**\* Revised Project \***  
**AGENCY COMMENT REQUEST**

**RE:** RZ17-3237, SD17-9466, & DP17-3010 – Proposed Subdivision of Parcel To  
Create Eight Single Family Residences  
214 Center Avenue, Pacheco, CA  
APN: 125-120-017  
Service Request #: SR0010913

**Subject:** Townhomes  
214 Center Ave., Pacheco, Ca  
File # SD17-09466, DP17-03010, RZ17-03237  
CCCFPD Project No.: P-2017-02430-REV1

**TO:** Jennifer Cruz, Senior Planner, Department of Conservation and Development  
**FROM:** Kara Schuh-Garibay, Civil Engineer, Engineering Services Division  
**SUBJECT:** **SUBDIVISION SD17-9466**  
**STAFF REPORT & CONDIITONS OF APPROVAL**  
(AYM, LLC/Center Avenue/Pacheco/125-120-017)  
**FILE:** SD17-9466 (x-ref DP17-3010 and RZ17-3237)

**Figure 1: SD17-9466 Vicinity Map with Alquist-Priolo Zones**

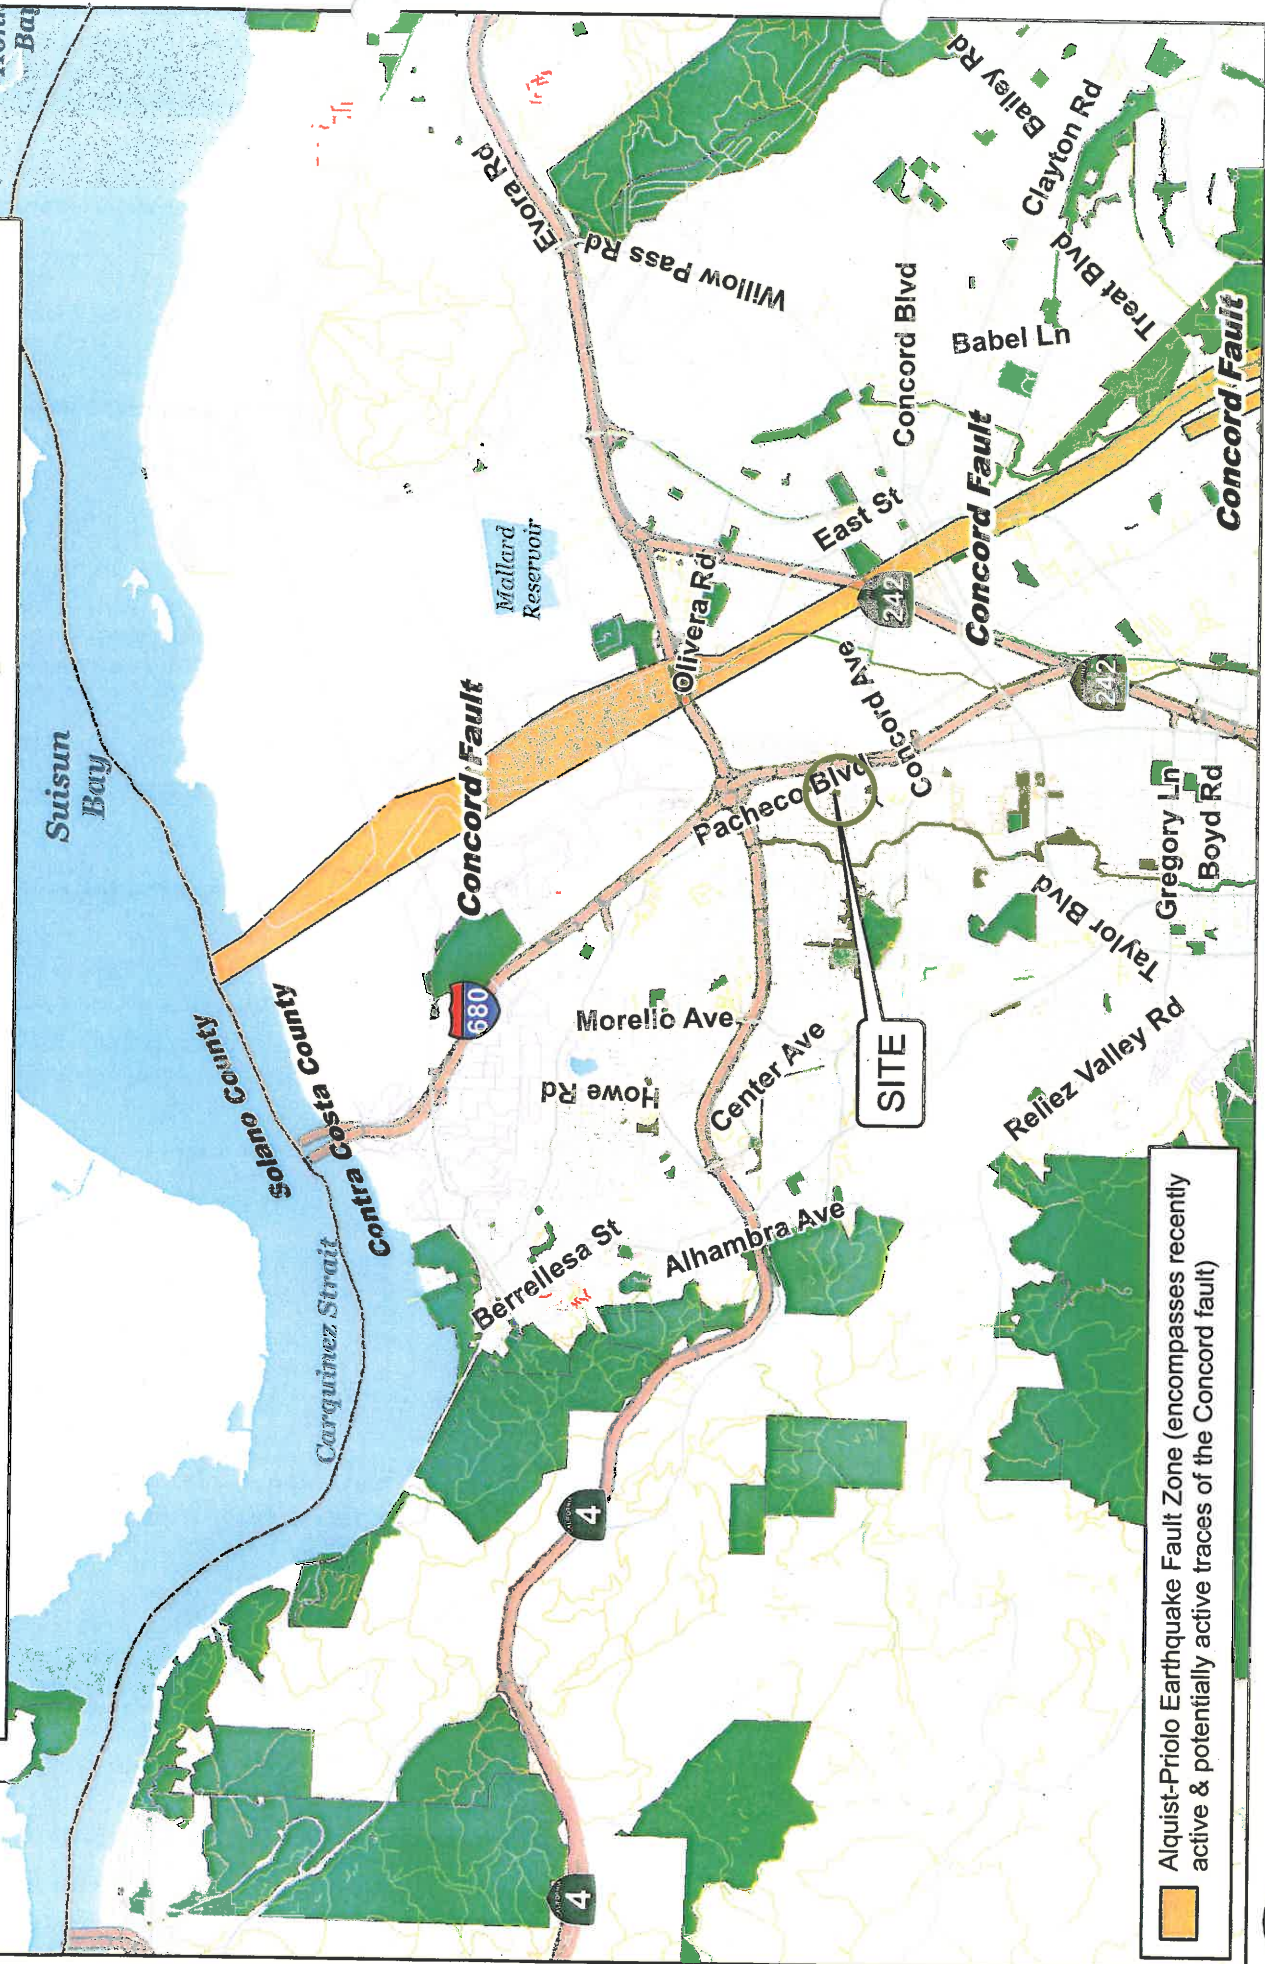
The site is located in the unincorporated Pacheco area. Figure 1, Vicinity Map that shows the location of the site on a base map that shows the local road network, major parklands (shaded green) and outlines the site boundary with a red line. For reference purposes, Figure 1 also shows the location of the Alquist-Priolo Earthquake Fault Zone (A-P zone) that encompasses recently active and potentially active traces of the Concord fault. It is the northwest-trending zone that is shaded orange, and passes approximately 1 mile northeast of the site. The A-P Zone was delineated by the California Geological Survey (CGS). Criteria used by the CGS to identify active faults there is clear evidence that surface fault rupture has occurred during Holocene time (i.e. during the last 11,000 years±). The Concord fault is characterized by right-lateral, strike slip displacement. Evidence of active faulting includes (i) groundwater barrier in Holocene alluvial deposits, (ii) evidence of shearing and off-set of Holocene deposits in exploratory trenches logged by geologic consultants for land development projects in the downtown Concord area, (iii) tectonic creep features in downtown Concord, (iv) geomorphic features characteristic of active faulting (e.g. scarp in Quaternary alluvial deposits). Alinement array data provides additional confirmation on the current rate of creep displacement on this fault during the period 1975-2003.<sup>6</sup> Evidence of seismic activity includes a magnitude 5.4 earthquake that occurred on October 24, 1954.

**Figure 2: SD17-9466 USGS Geologic Map**

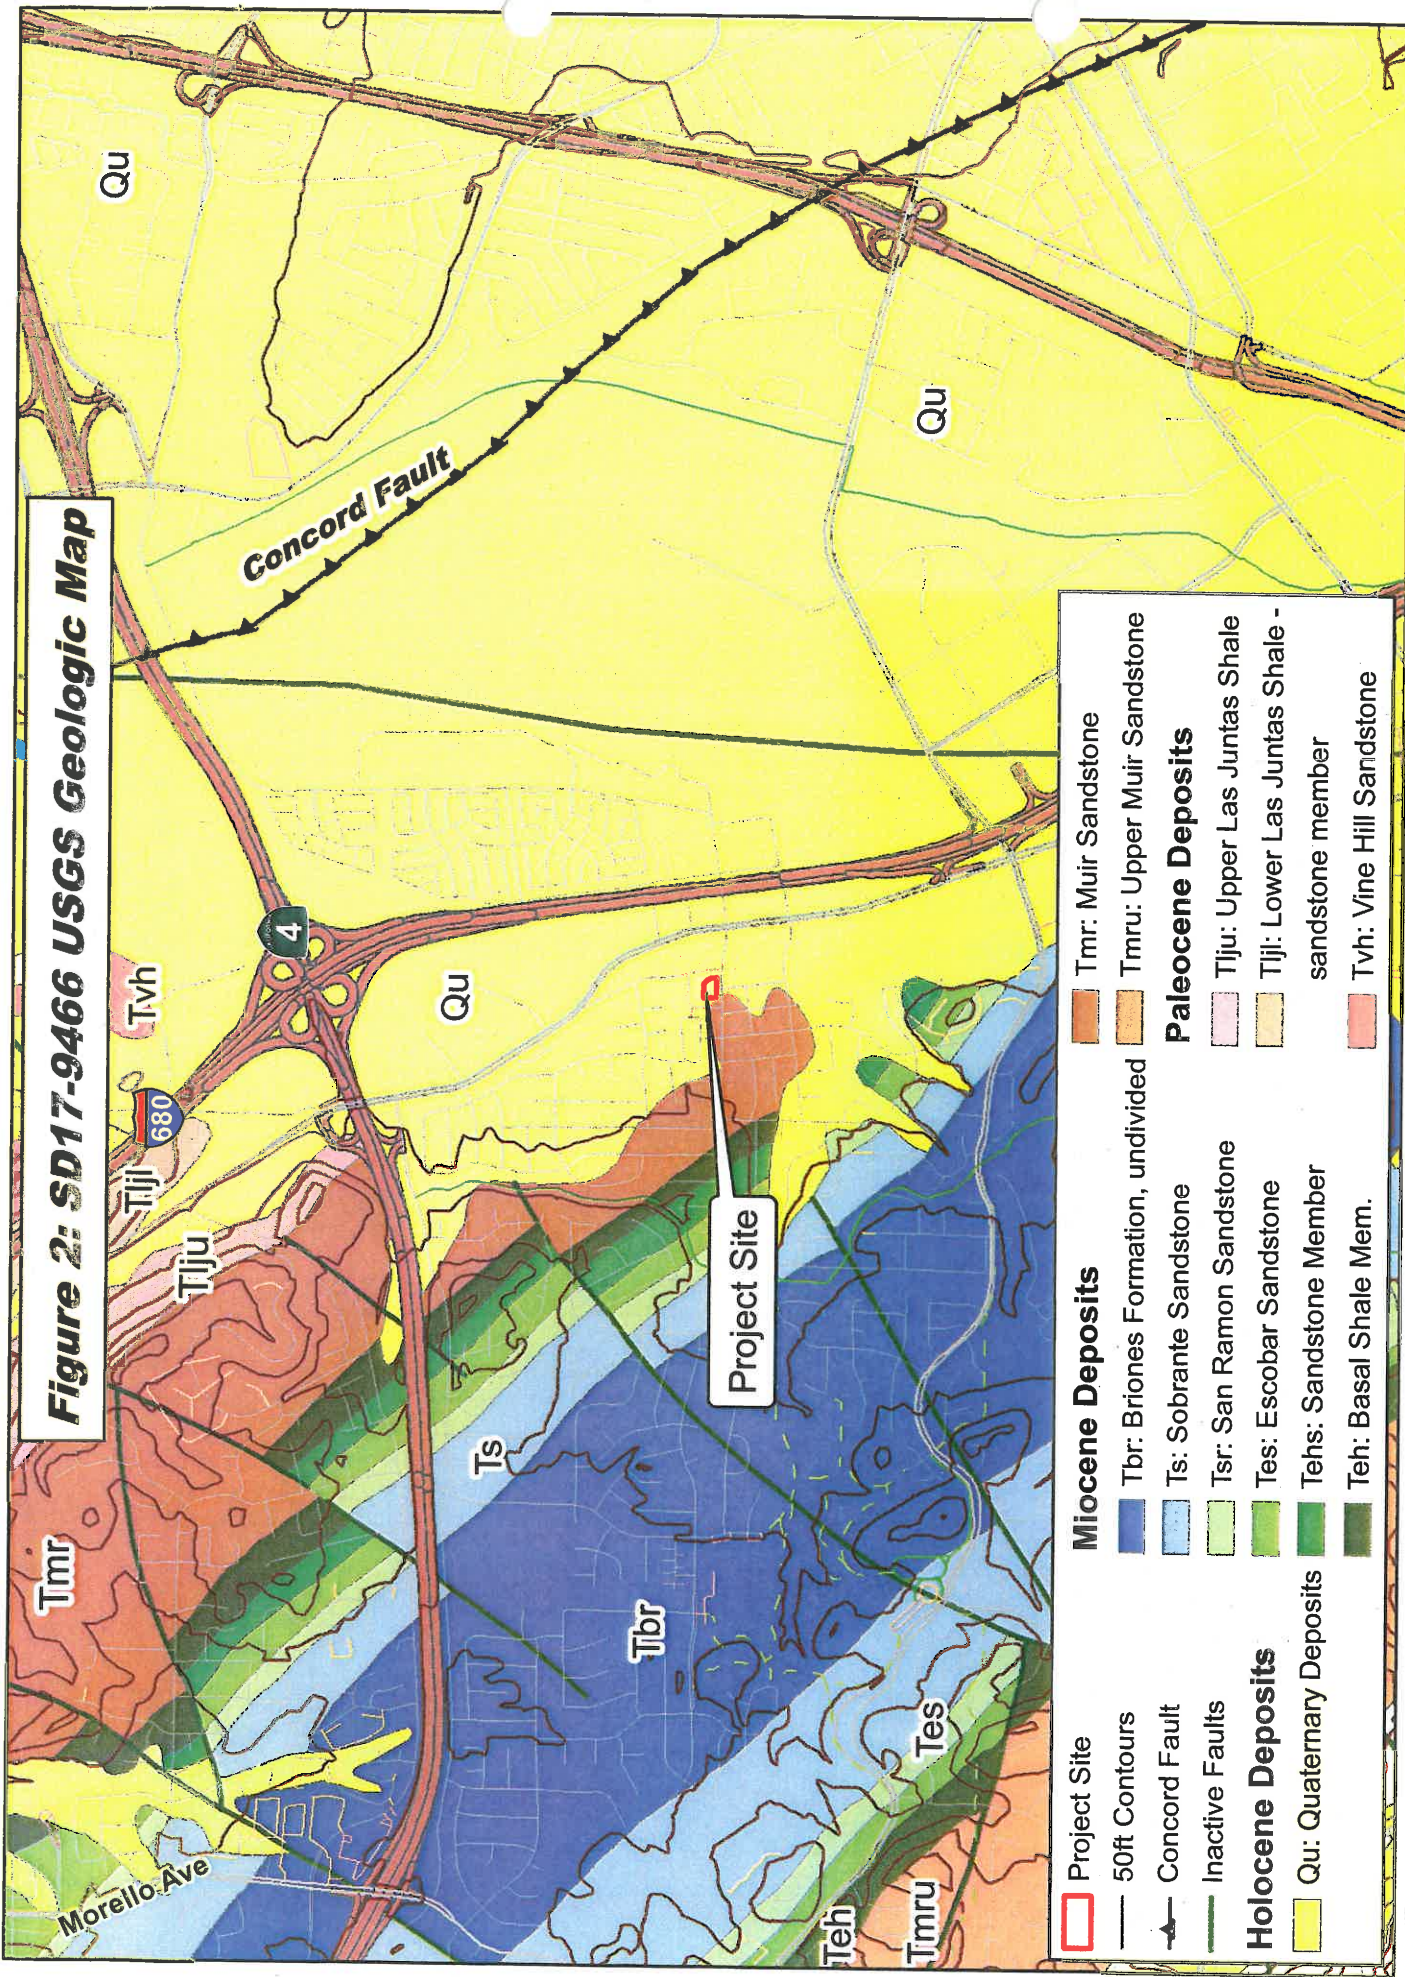
In 1994 the U.S. Geological Survey (USGS) issued a digitized geologic map of Contra Costa County that emphasized bedrock formations.<sup>7</sup> This map is presented in Figure 2. It indicates the property is located within the within an area mapped as *Quaternary Deposits* (Qu), on the westernmost flank of the Diablo

Valley. The nearest bedrock exposure is immediately west of the site, within the outcrop belt of the Muir Sandstone (Tmr) of Eocene age. It consists chiefly of massive, yellow-weathering, arkosic sandstone. With regard to geologic structure, the site is located on the northeast limb of the Pacheco Syncline. (The axis of the syncline is within the outcrop belt of the Briones Sandstone (Tbr).) By extrapolation from nearby measurement, bedding in the Muir Sandstone can be inferred to dip southwest at 60 to 65°. No faults are mapped on the site. The nearest faults shown in Figure 2 are a series of short, northeast-trending tear faults located in the hills west and north of the site. These faults are considered to be inactive by both the USGS and CGS. Additionally, a generally north-south trending fault is shown passing ½ mile east of the site. The mapping of this fault is based on deep geophysical obtained by the USGS from the files of petroleum firms. There is no surface manifestation of this fault, and the geophysical data does not confirm that the fault cuts any Quaternary deposits. This inactive fault intersects the Concord fault just north of State Route 4, approximately 2½ miles northeast of the site. As shown in Figure 2, the Concord fault closely coincides with the alignment of the channel of Walnut Creek, and passes 1 mile northeast of the site. Another USGS publication refers to the Muir Sandstone as the Domingue Formation (Map Unit 376 in USGS Professional Paper 1357).<sup>8</sup> Ellen and Wentworth acknowledge that as they interpret the data, Unit 376 is equivalent to the Muir and Escobar Sandstones mapped by C.E. Weaver on the east limb of the Pacheco Syncline.<sup>9</sup> The composition of Unit 376 can be summarized as follows:

**Figure 3: SD17-9466 USGS Quaternary Geology Map**

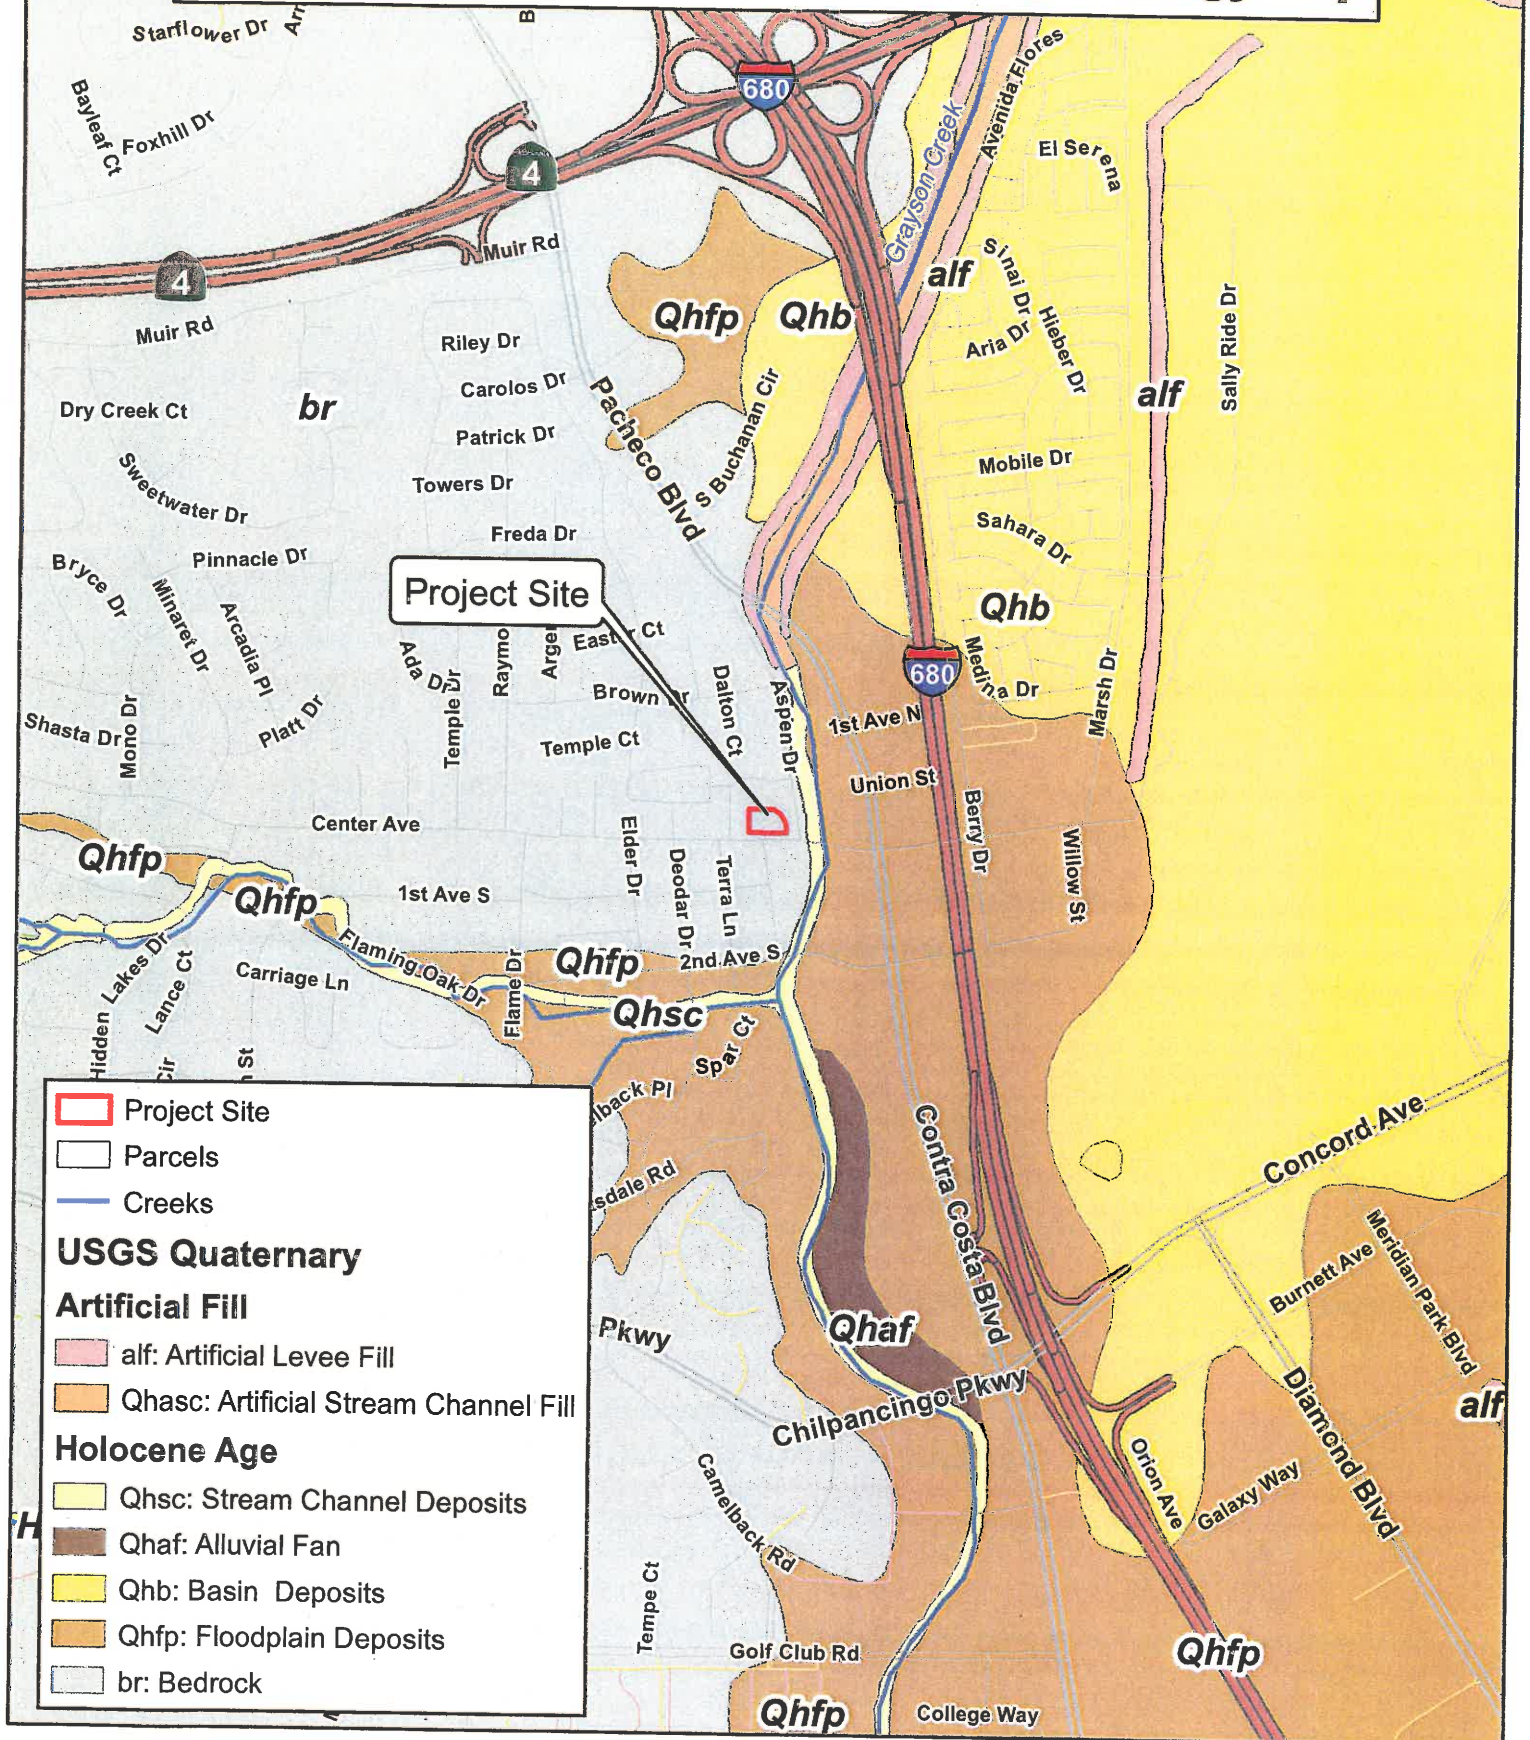
In 1997 the USGS issued a map that divided Quaternary deposits of Contra Costa County into units that vary in (i) age, (ii) depositional environment and (iii) engineering properties.<sup>10</sup> In Figure 3, the boundary of the site is outlined with a red line. According to this map the site is interpreted as a bedrock terrace that is slightly elevated above the valley floor. Note that Figure 3 does not attempt to show the distribution of landslide deposits. However another USGS investigation produced a set of maps of the County that were based solely on geologic interpretation of aerial photographs, without the benefit of a site visit or any subsurface data. The maps were prepared by an experienced USGS geologist, who mapped the distribution of suspected landslides based on geomorphic features. The map of the site and vicinity is presented in Figure 4 at a scale of 1 in. = 1,000 ft.<sup>11</sup> The site boundary is outlined in green. The landslides are outlined in red, with a black arrow indicating the general direction of downslope displacement. These maps do not show landslides that may have formed since 1975, and the slides shown are not classified on the basis of the activity status (i.e. active or dormant), depth of slide plane (shallow or deep seated), or type of landslide deposit. The USGS maps which are included in the Safety Element, and are used to "red flag" project sites that may be at risk of landslide damage. Figure 4 indicates no suspected landslides within ½ mile of the site. Consequently, landslide risks appear do not appear to be significant.
